MEMORANDUM

RE: Report on revised Wayland MPS Application: Signage, Landscape,

Streetscape and Lighting

The following is the second review by The Cecil Group of the landscape plans submitted by the applicant for the Wayland Master Special Permit Application for the Wayland Town Center Mixed Use Overlay District (MSP submittal). This memo follows two previous review memos.

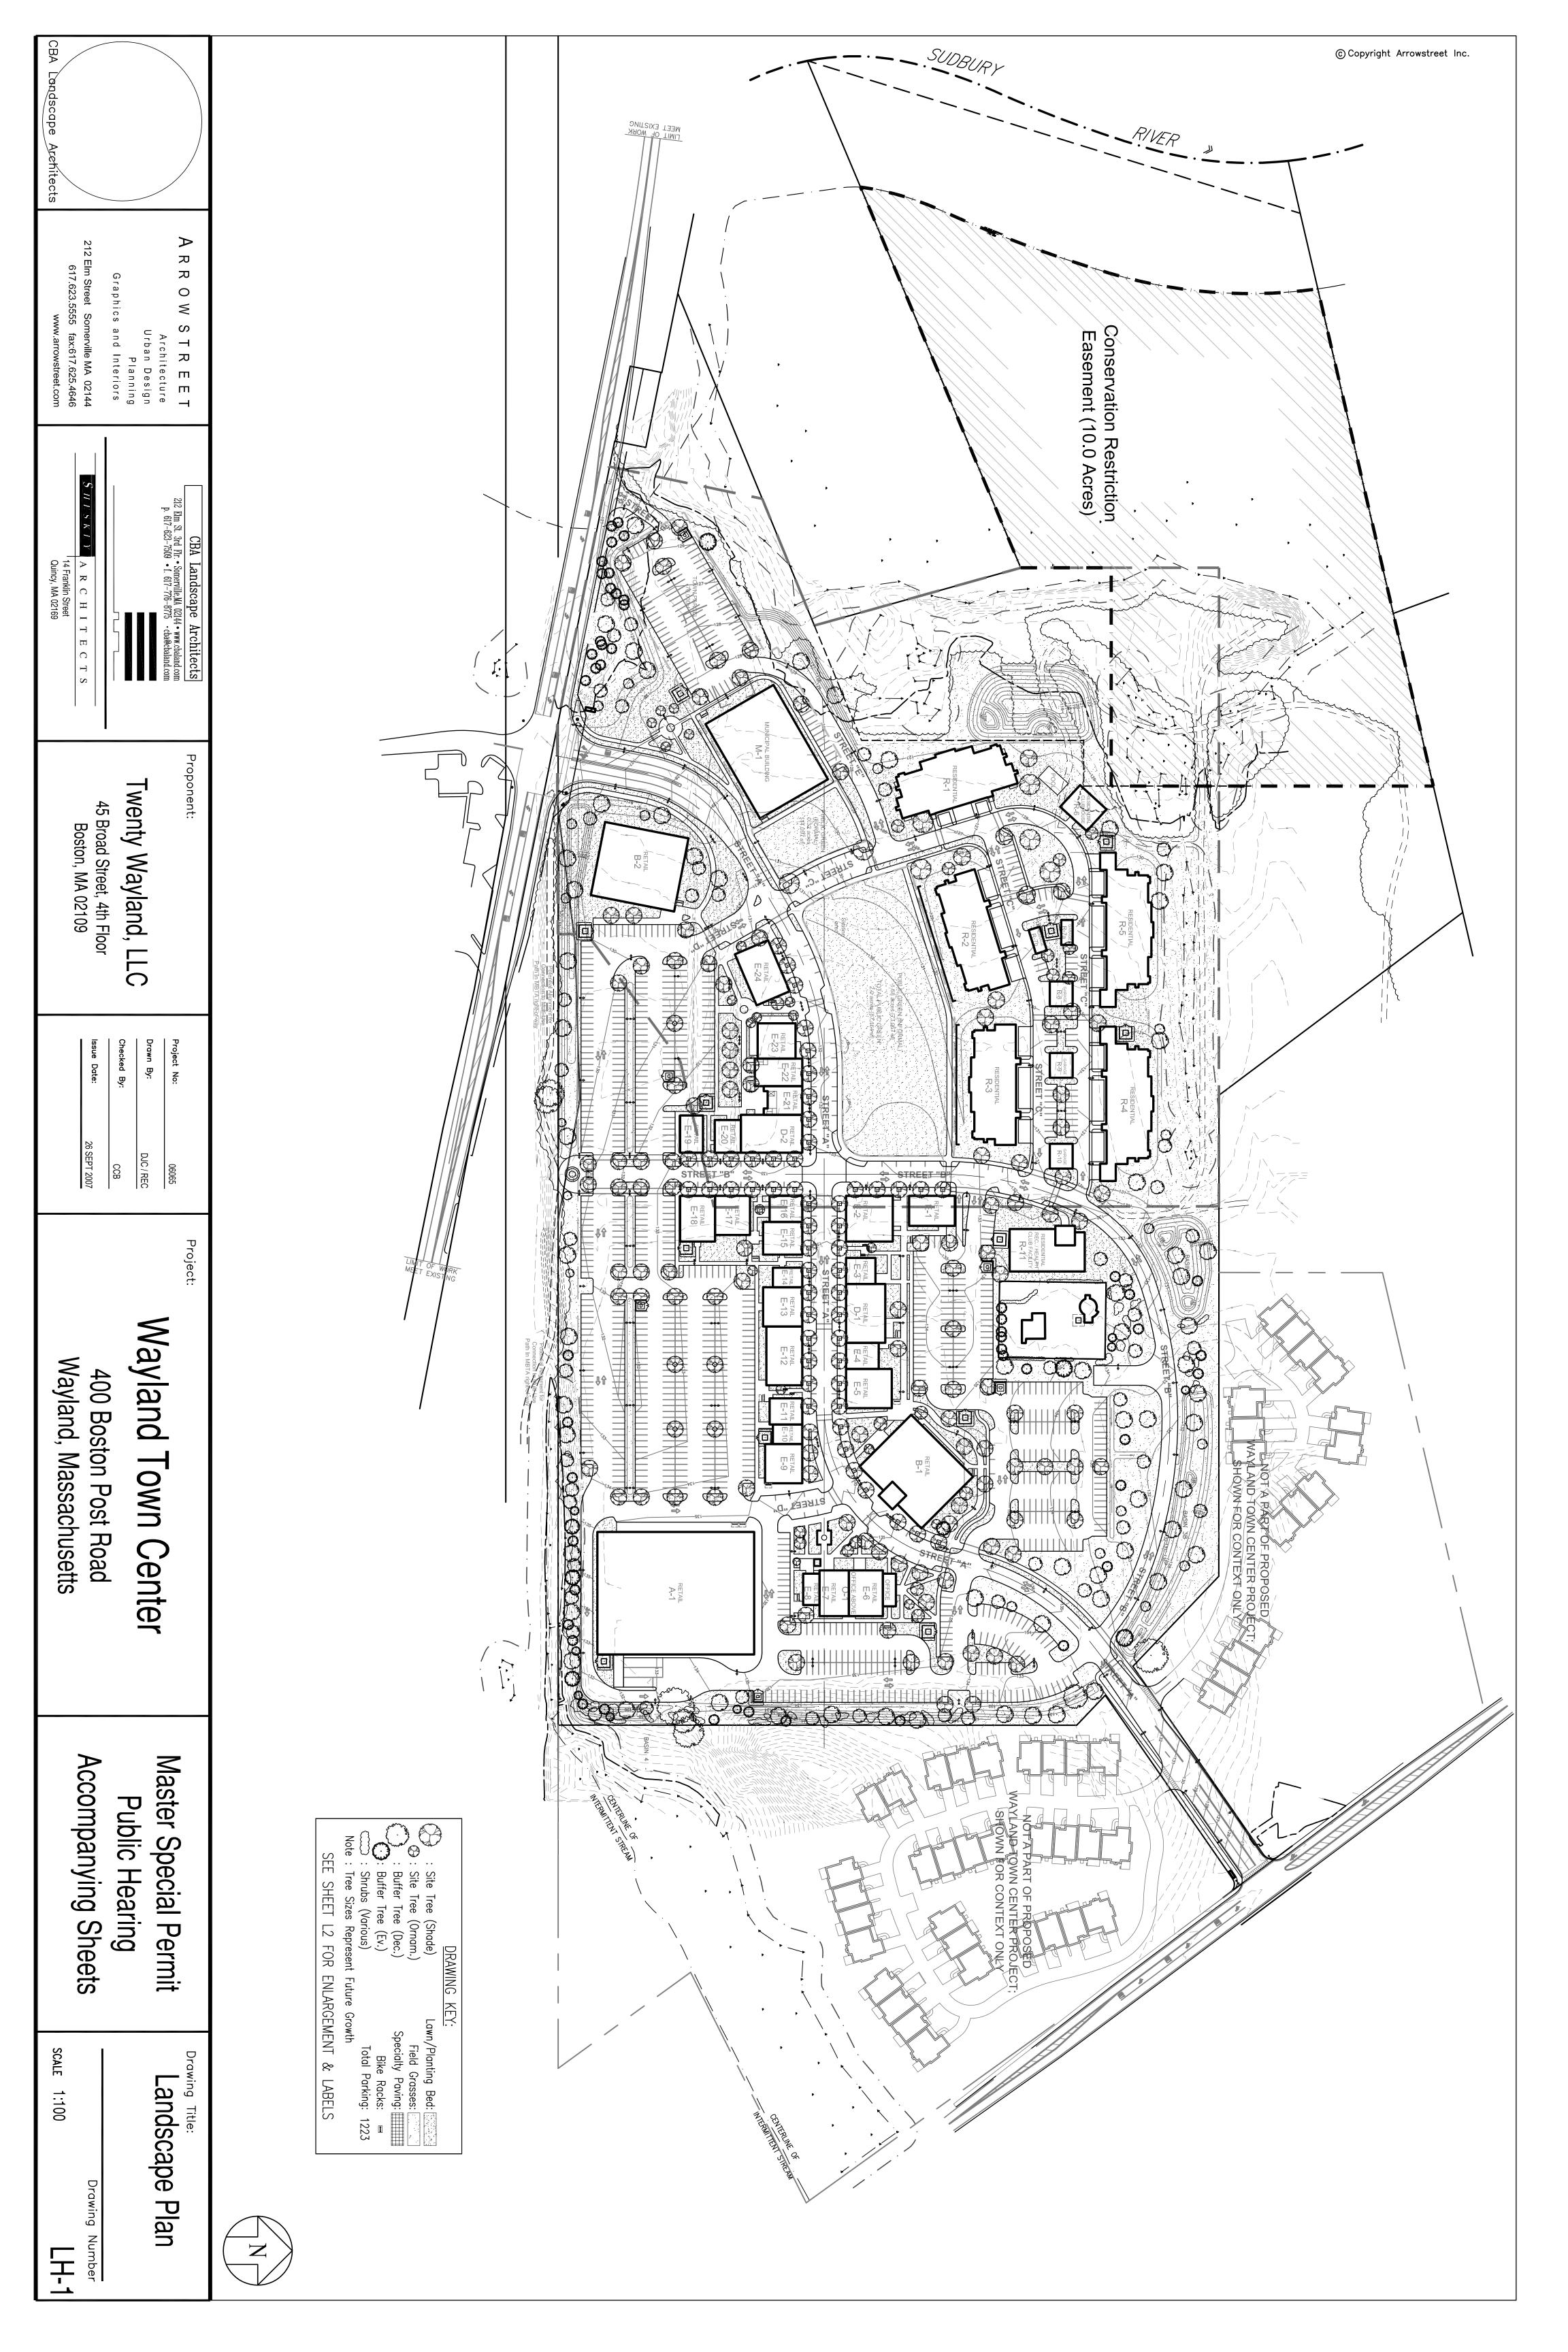
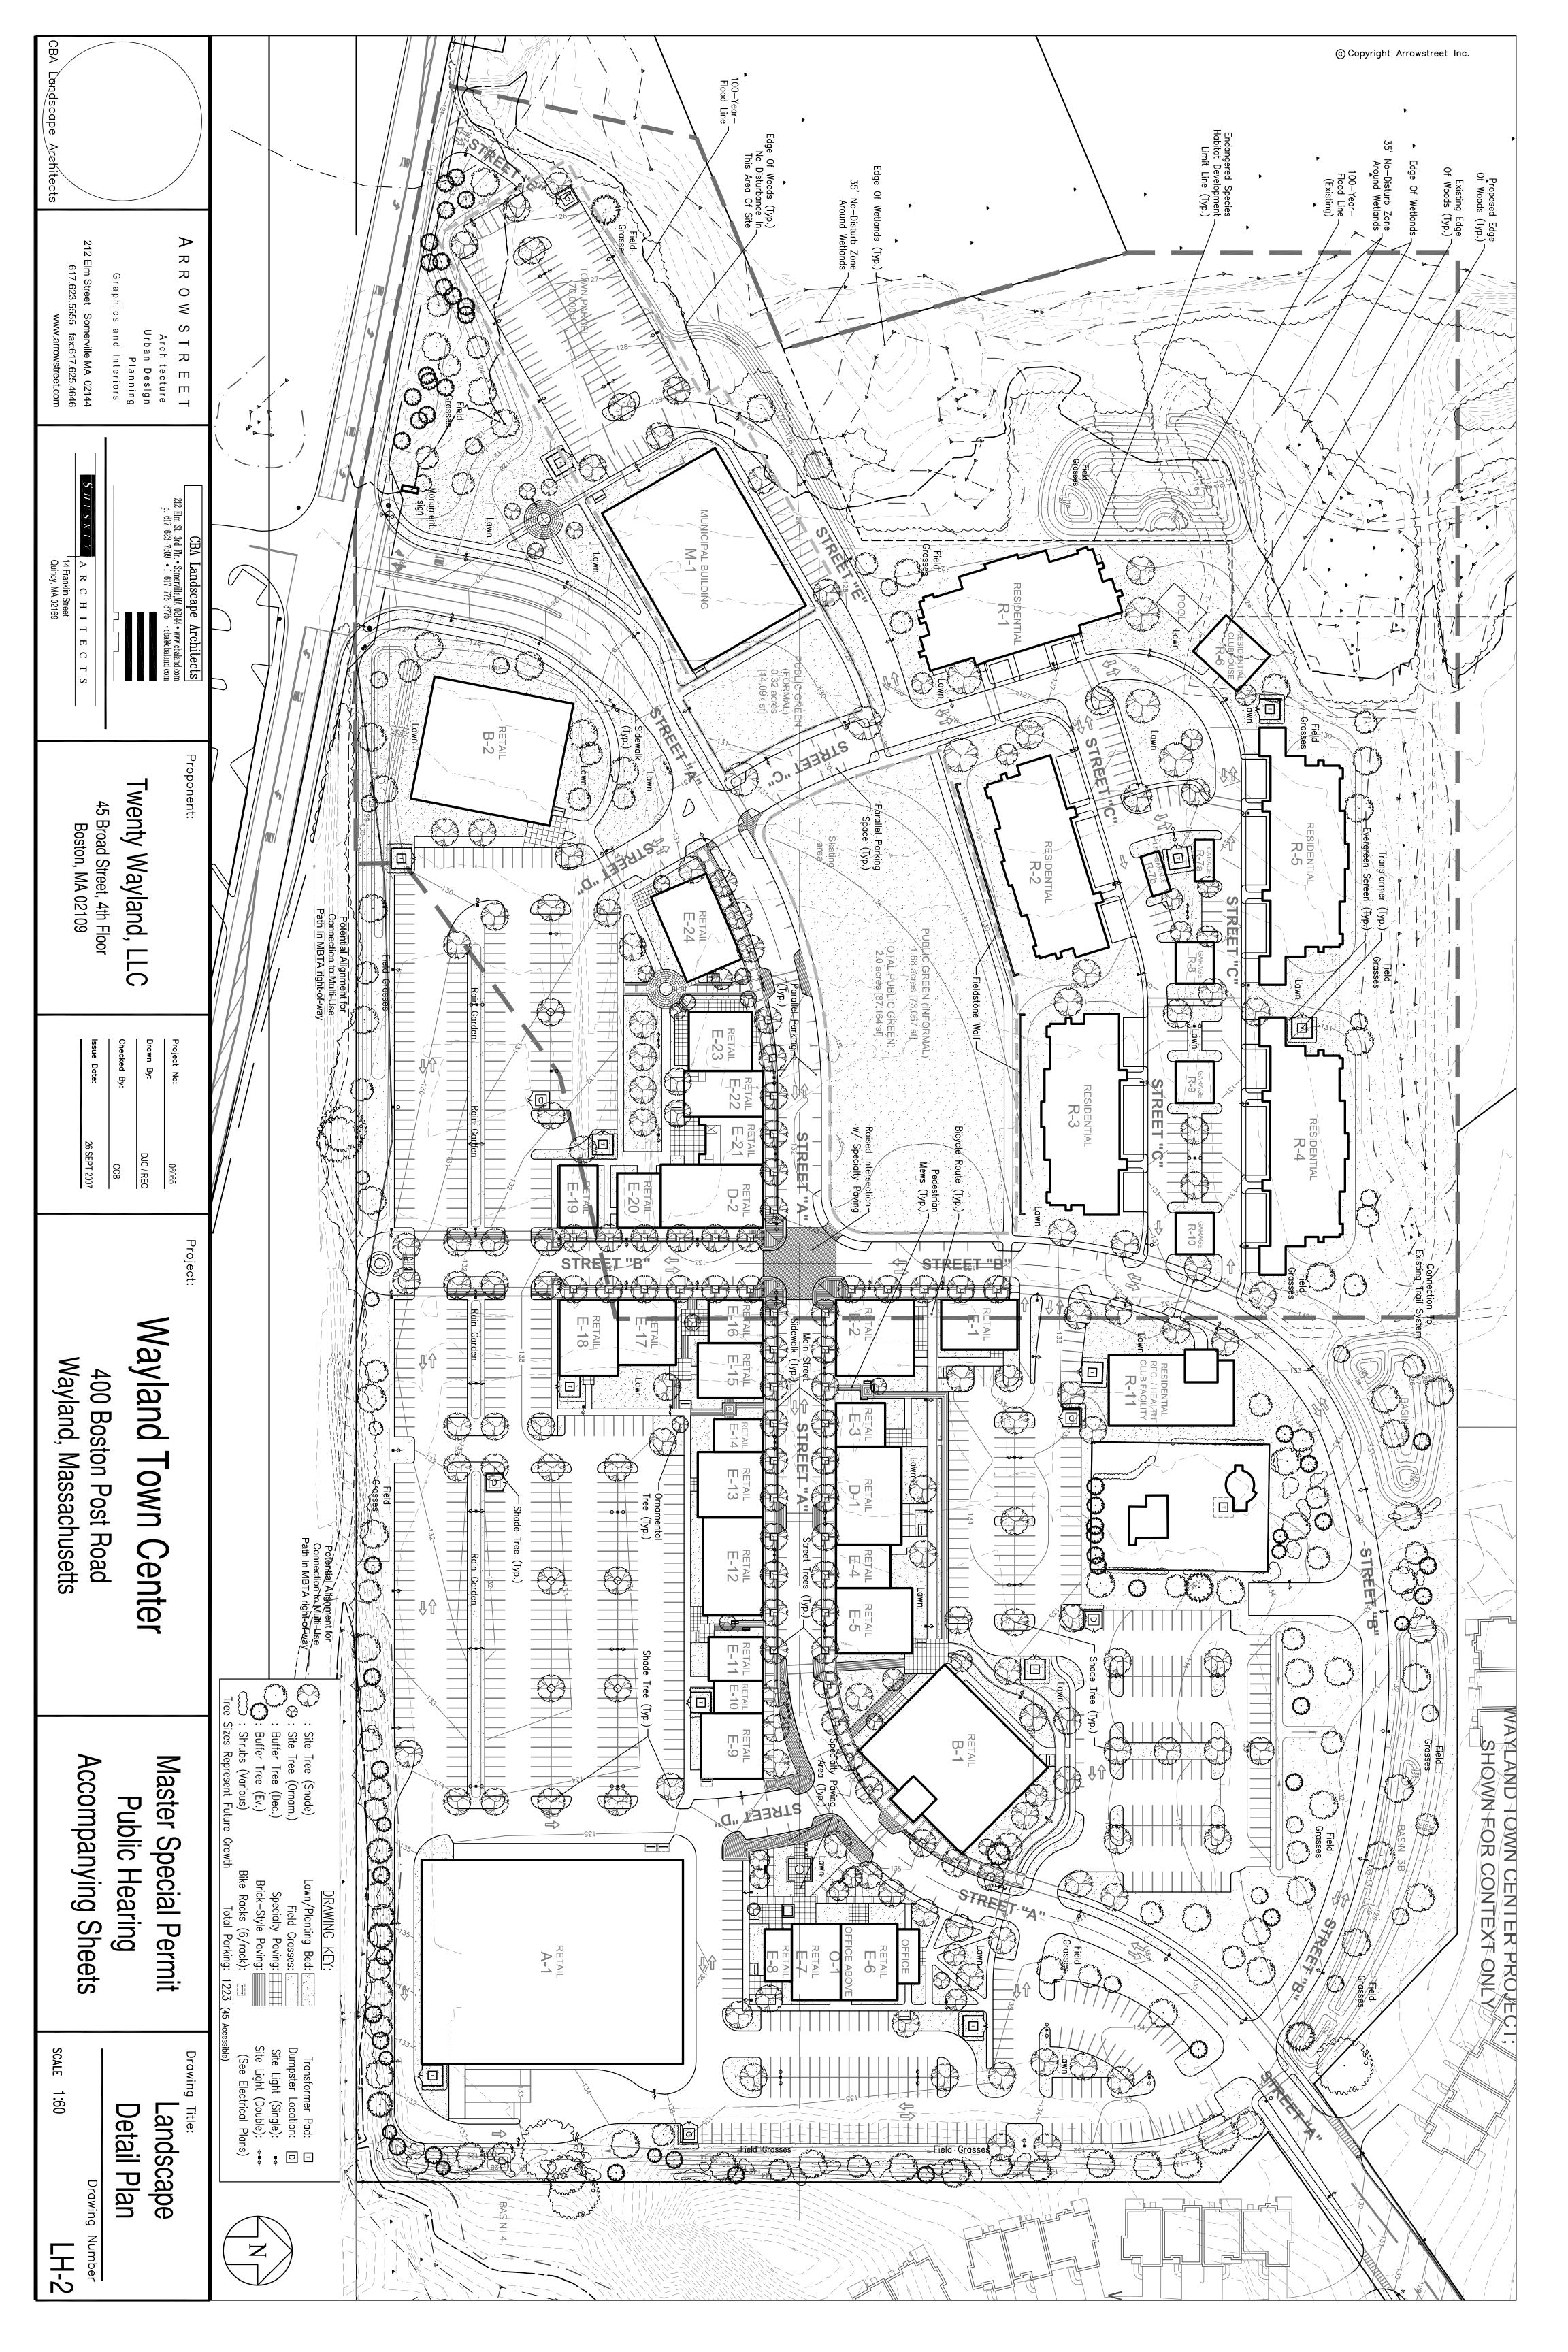
- 1. The site plans both at 1:10 and 1:60 scale show tree plantings but not shrubs. However, shrubs are indicated in the cross-sections. The previously planting plans, L-1 through L-6, include plant schedules that must be updated to conform to the revised planting plans on the 'LH' sheets and include the shrub plantings.

- 2. The new site plans show additional tree plantings not indicated on the original MSP submittal. The previously planting plans, L-1 through L-6, include plant schedules that must be updated to conform to the revised planting plans on the 'LH' sheets.

- 3. The 1:10 scale details indicate such callouts as "specialty paving," and "secondary sidewalks," without providing more clarity as to what these entail or the level of quality and construction. The specialty paving could include a range of options from pressed asphalt to brick pavers, which we consider a very broad range of options.
